Page	Place	Error	It should be
66	equation 6.16 line 1	$\sigma_{\max} = ...$ for $a \geq \frac{1}{2}$	$\sigma_{\max} = ...$ for $a \leq \frac{1}{2}$
66	equation 6.16 line 3	$\sigma_{\max} = ...$ for $a \leq \frac{1}{2}$	$\sigma_{\max} = ...$ for $a \geq \frac{1}{2}$
122	first line below phase angle	reference to equation 10.14	should be to equation 10.15
164	equation 13.3	k_{AC}	k_{BC}
168	thickness in figure of thin tube	$t = q$	$t = \frac{q}{2}$
170, 171	equations 13.12, 13.13, 13.15	θ could have been expressed in L and h	$k_{\text{truss}} = \frac{Eh^3Lt}{4L^4 + 4L^2h^2 + h^4}$
171	equations 13.14, 13.16	ht^3	h^3t
171	above figure 13.27	height to length ratio h/L	length to height ratio L/h
171	last sentence	stiffness almost the same as the stiffness of the sheet	that is not the case, it is not almost the same

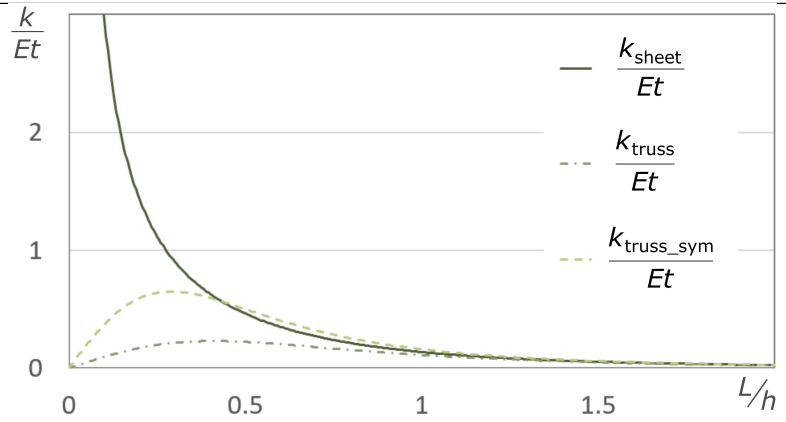
Page	Place	Error	It should be
172	figure 13.28	stiffness of symmetrical truss should be as in figure:

172	equation 13.18	equation of stiffness is wrong	$k_{\text{truss2}} = \dfrac{4ELh^3t}{16L^4 + 8L^2h^2 + h^4}$
172	below equation 13.18	stiffness almost the same as the stiffness of the sheet	that is not the case, it is not almost the same
178	equation 13.24	$\omega_1 = ...$	$\omega_{n1} = ...$
190	equation 13.31	$L(1-\cos\alpha) \approx \dfrac{\alpha^2}{2}$	$L(1-\cos\alpha) \approx \dfrac{\alpha^2 L}{2}$
224	equation 16.4	$U = ... = \dfrac{1}{2}m\omega^2 r^2\big(\sin(\omega t) + \cos(\omega t)\big)^2 = m\omega^2 r^2$	$U = ... = \dfrac{1}{2}m\omega^2 r^2\big(\sin(\omega t)^2 + \cos(\omega t)^2\big) = \dfrac{1}{2}m\omega^2 r^2$
225	equation 16.4	$y = L_{\text{beam}}\cos(\theta) z = L_{\text{beam}}\sin(\theta)$	$y = L_{\text{beam}}\cos(\theta) \qquad z = L_{\text{beam}}\sin(\theta)$
